SERVICE BULLETIN

Service Bulletin No.: DA20-72-02 Rev 0

Title: DA20-A1 – Evans NPG+ Coolant

CHANGE OF COOLANT SPECIFICATION ON ROTAX® ENGINE TYPE 912 AND 914 (SERIES)

The following drawings should provide additional information: See fig. 1

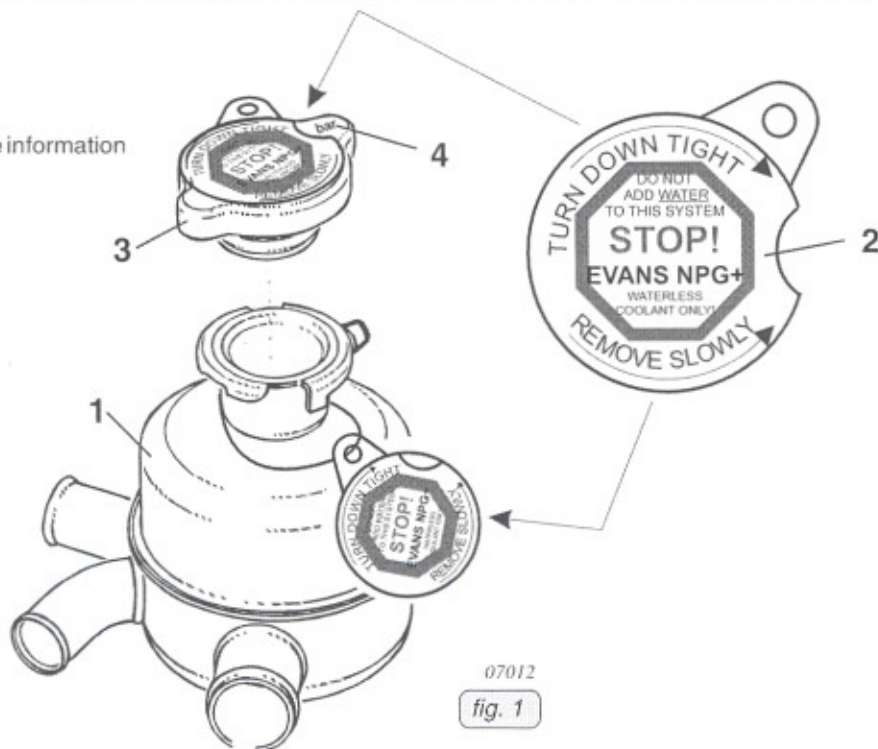
◆ **NOTE:** On the radiator cap (3), to identify the new coolant, the warning label (2) is to be affixed so that the opening pressure data (4) is visible.

- For new engine deliveries the sticker will be temporarily attached to the expansion tank.
- The sticker has to be affixed to the radiator cap in accordance to the aircraft manufacturer's instruction.
